• 2014 DRC SUBMISSION – Proposed revisions to Tucson 2 project

LIST OF PROPOSED CHANGES

The Hub at Tucson II

CHANGES SUBMISSION. **PROPOSED**

EXISTING 13 STORY BUILDING

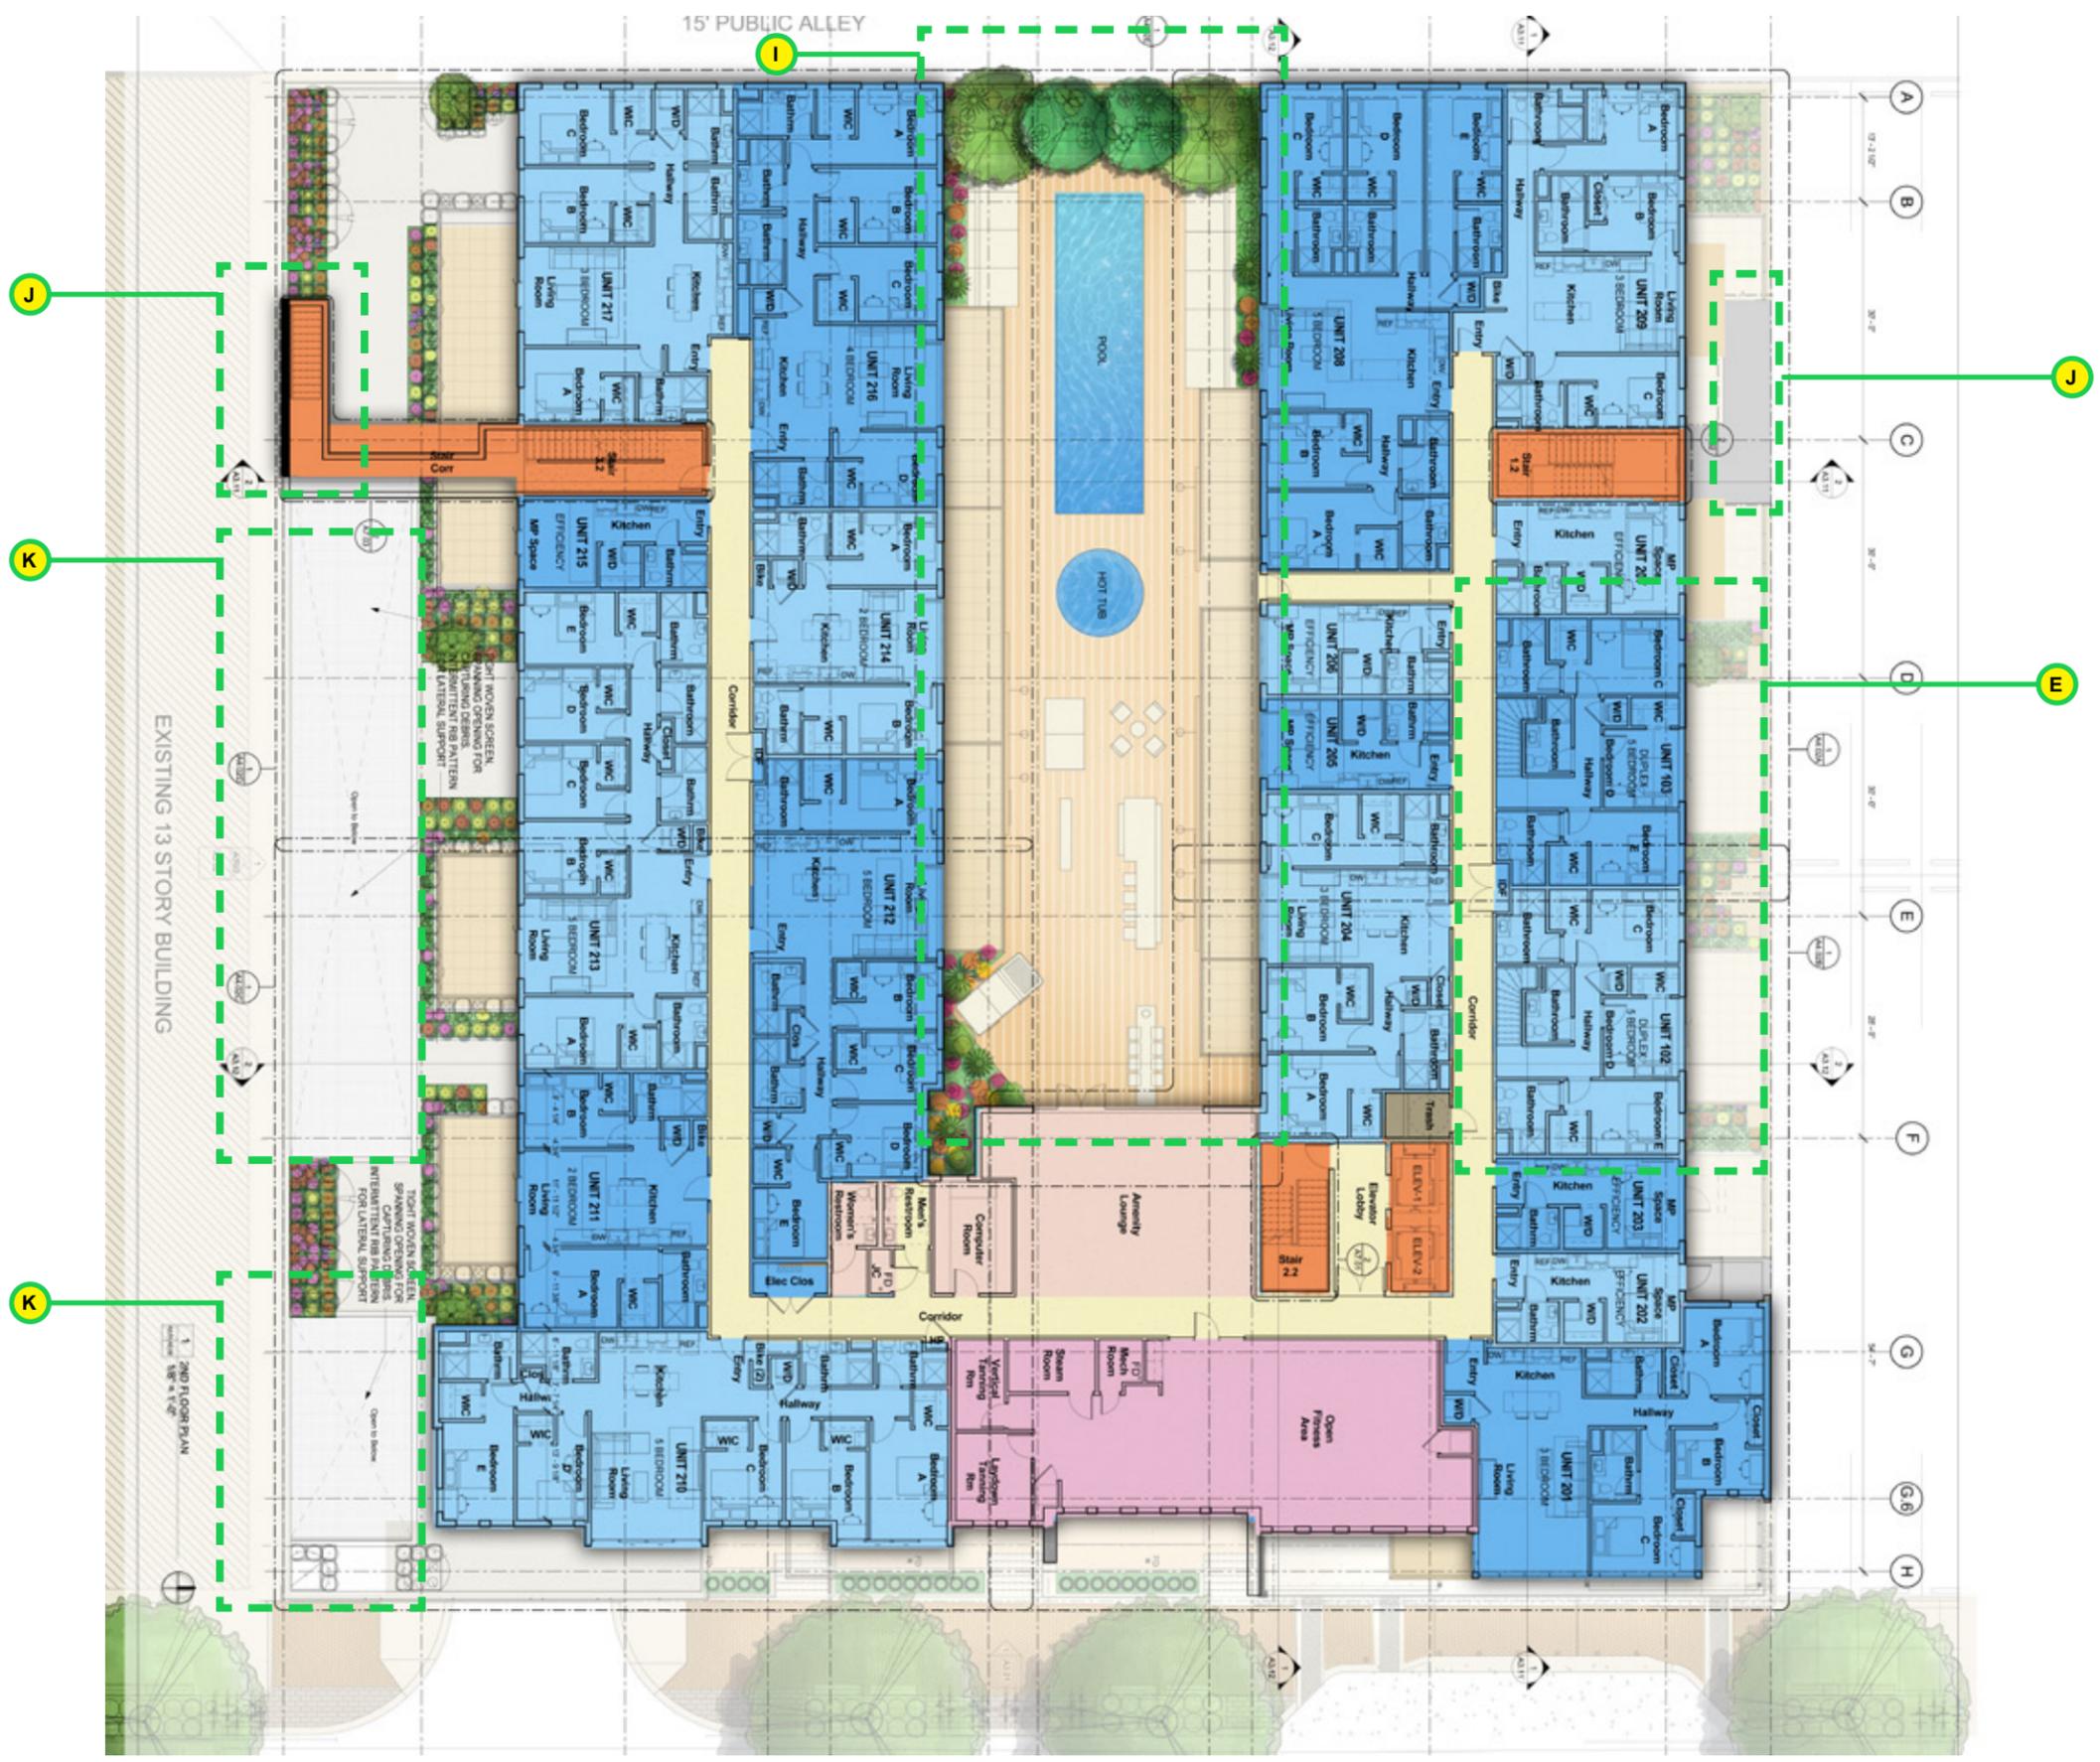
- **D** - Addition of mezzanine units to the north wing of the building.
- **E** - Duplex units added to center of north wing and balcony arrangement altered. Associated Balconies increase in width from 15' to 18'. Layout and extent of glazing on north façade changed from 3,006 sqf (Approved scheme) to 3,784sqf (Proposed scheme), resulting in 778 sqf of additional glazing.
- **F** - Rooftop terrace area reduced, pool and hot tub relocated to the courtyard. Rooftop terrace screen material changed from glass infill to metal panel infill. Extent of mechanical screen increased to location on the north wing. Landscaping altered to suit new layout.
- **L** - All balconies reduced from 6' to 5' deep, excluding balconies on Tyndall street.
- **Q** - Number of balconies reduced on the north and south elevations from 26 to 16.

PERCENTAGE OF FIRST FLOOR TO MEZZANINE AREA	
TOTAL GFA OF FIRST FLOOR	35,737 sqf
TOTAL GFA OF MEZZANINE	7,900 sqf
TOTAL GFA PERCENTAGE	22%

PROPOSED POOL AREA COMPARED TO APPROVED	
APPROVED POOL AREA	828 sqf
PROPOSED POOL AREA	440 sqf
POOL AREA REDUCED BY 388sqf

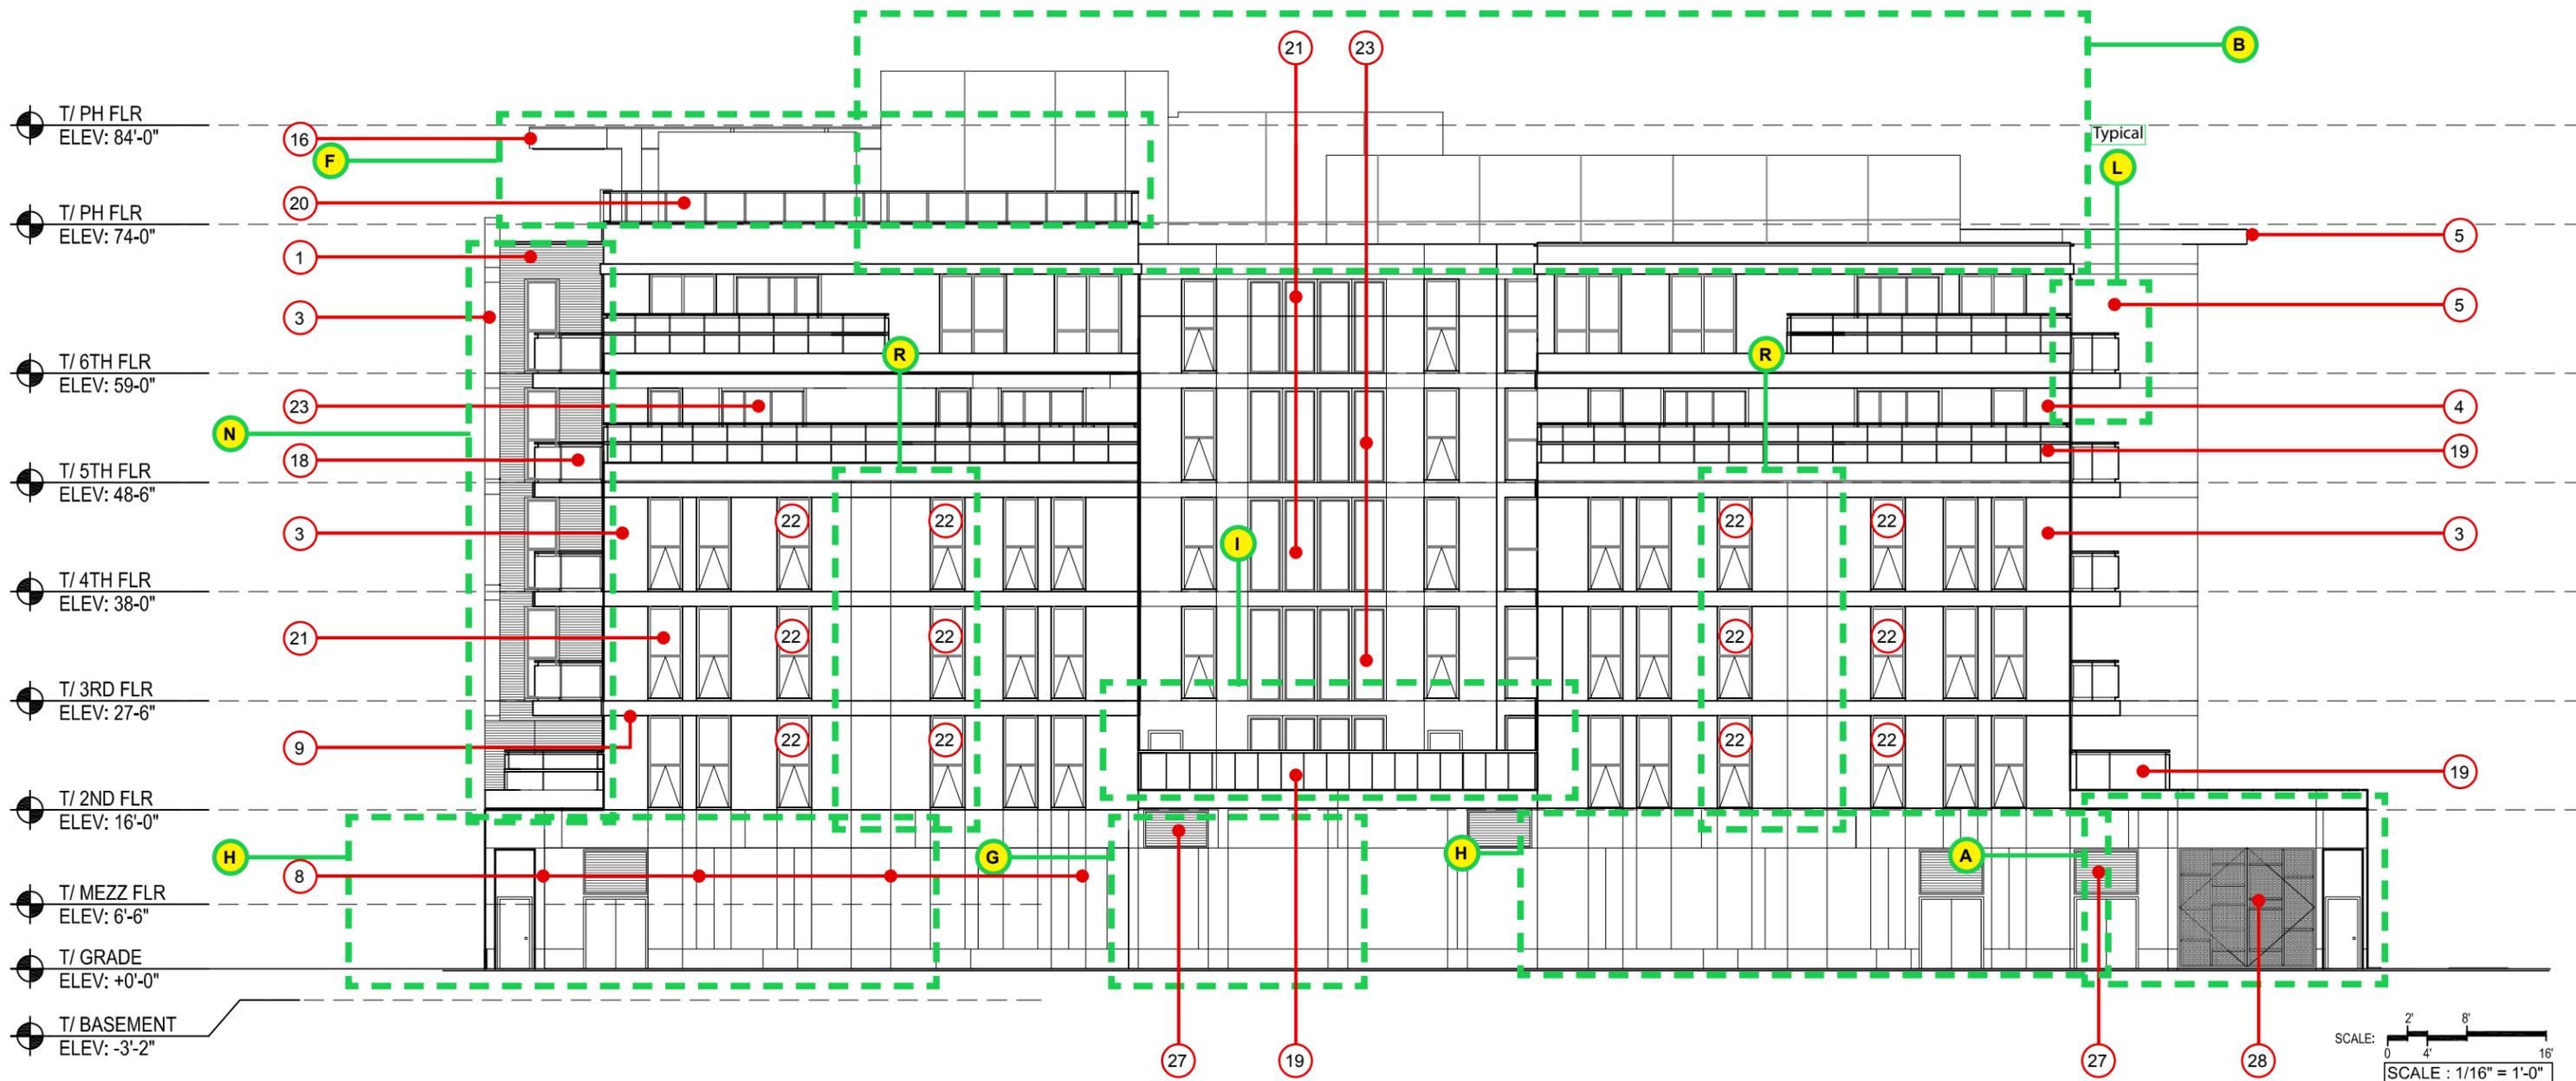
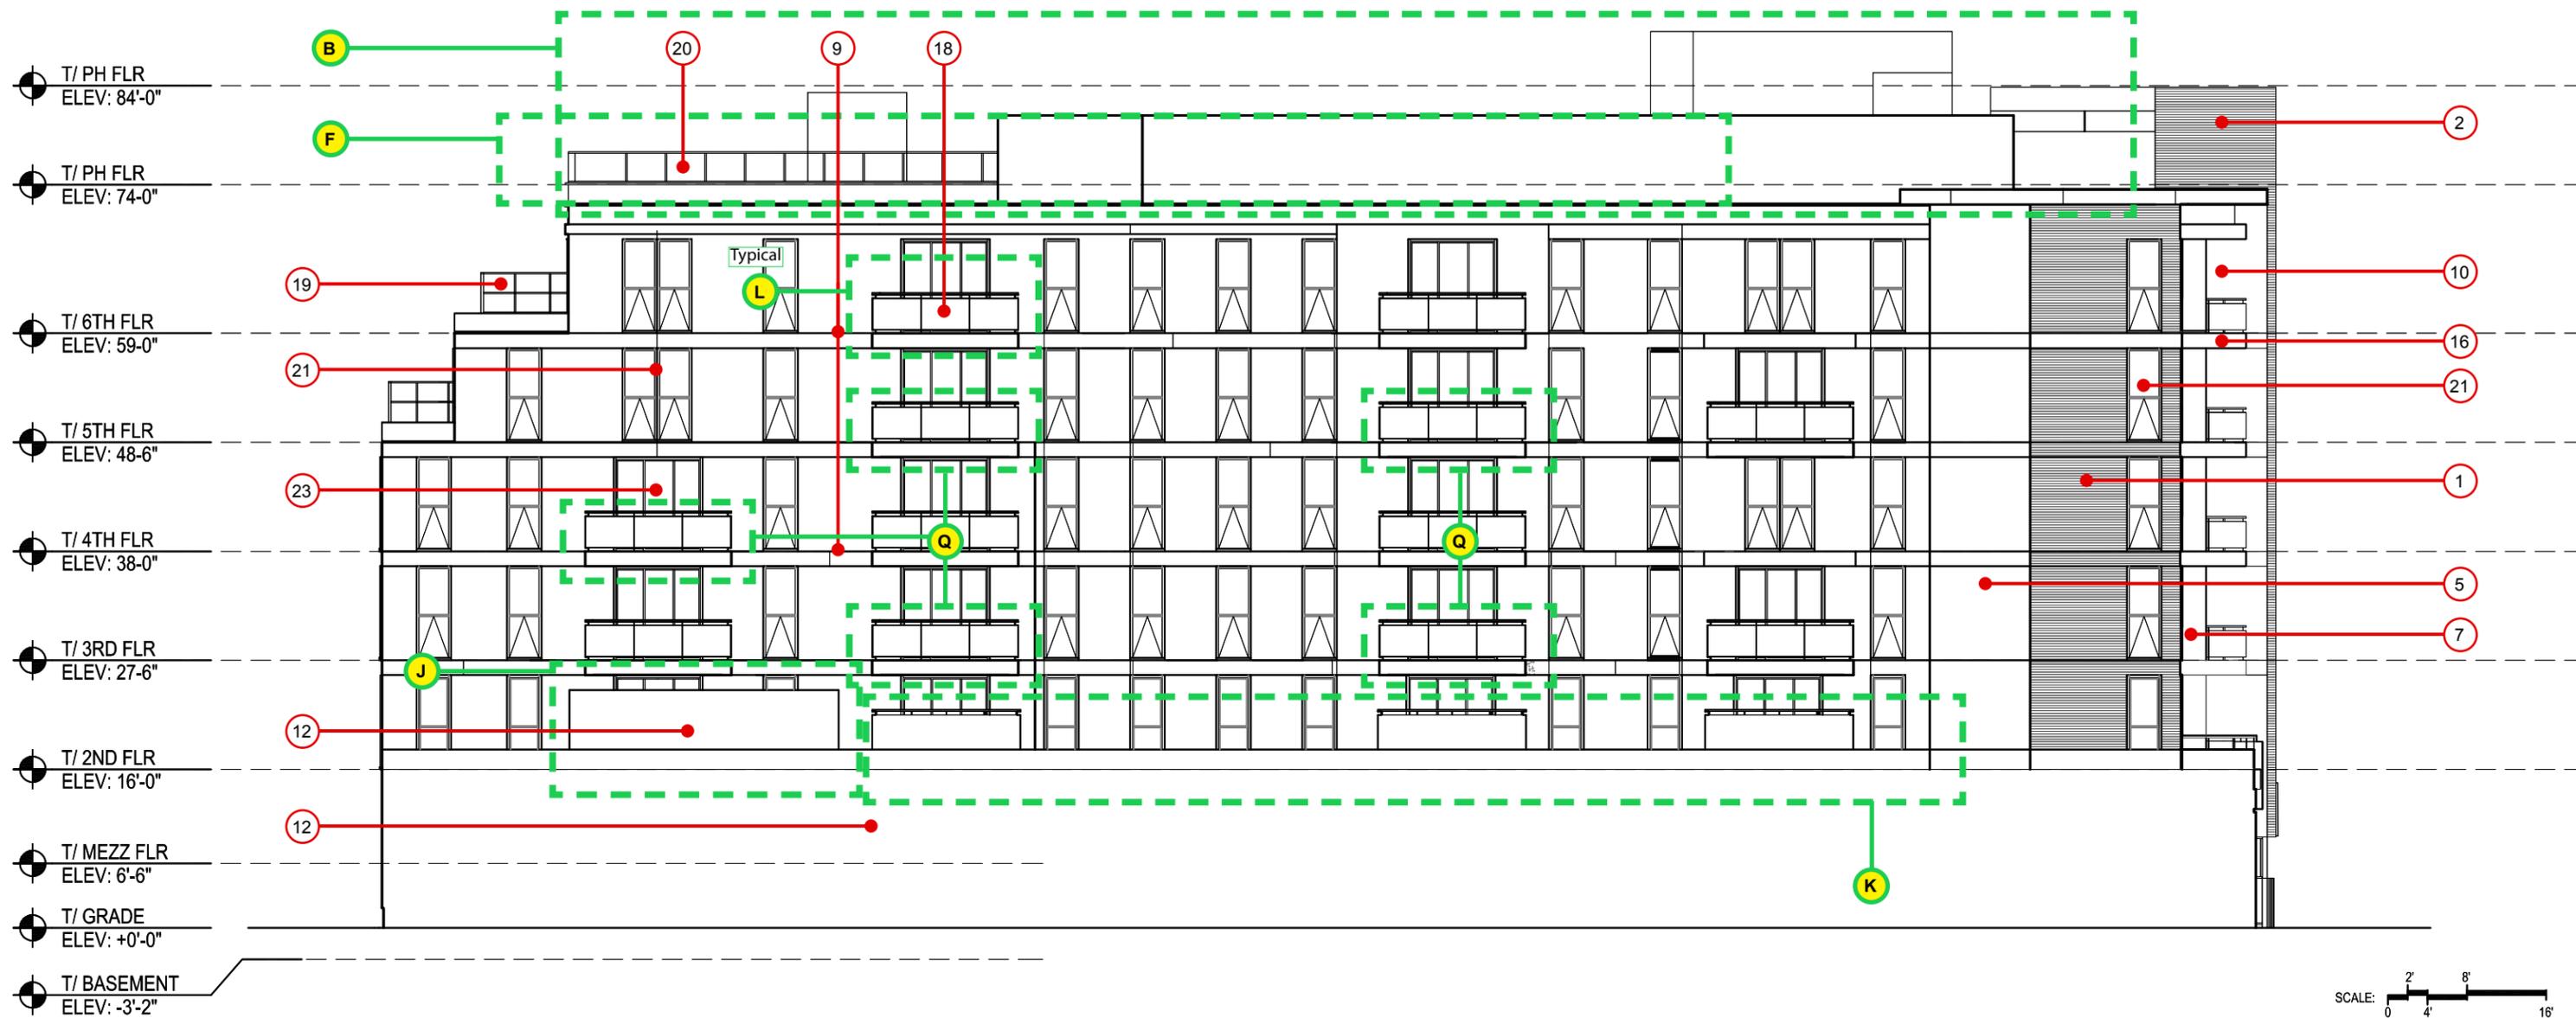
- **A** - Water meter enclosure and transformer room relocated from west alley to the Tyndall street facade. Garage door size reduced.
- **B** - Mechanical screen altered. Secondary screen removed and parapet height increase to 5' to act as screen, pool equipment room removed, elevator shaft footprint reduced and the elevator top of parapet height increased from 86' to 90' to allow for the mechanical lift overrun. 6th floor ceiling height increased by 1' with the south "I" eyebrow lifting by approx 1'10".
- **F** - Rooftop terrace area reduced, pool and hot tub relocated to the courtyard. Rooftop terrace screen material changed from glass infill to metal panel

infill. Extent of mechanical screen increased to location on the north wing. Landscaping altered to suit new layout.

- **G** - Revised gas meter recess location.
- **H** - Loading dock recess removed, egress door added and stucco color pattern altered to suit.
- **I** - Pool and hot tub relocated to courtyard. Screen wall height increase from 6' to 8' and landscaping altered to provide an acoustic barrier to the alleyway.
- **L** - All balconies reduced from 6' to 5' deep, excluding balconies on Tyndall

- **N** - Windows moved away from adjacent balconies.
- **R** - Vision windows added to dark band and spandrel glass windows changed to vision glass. Changes due to unit layout alterations.
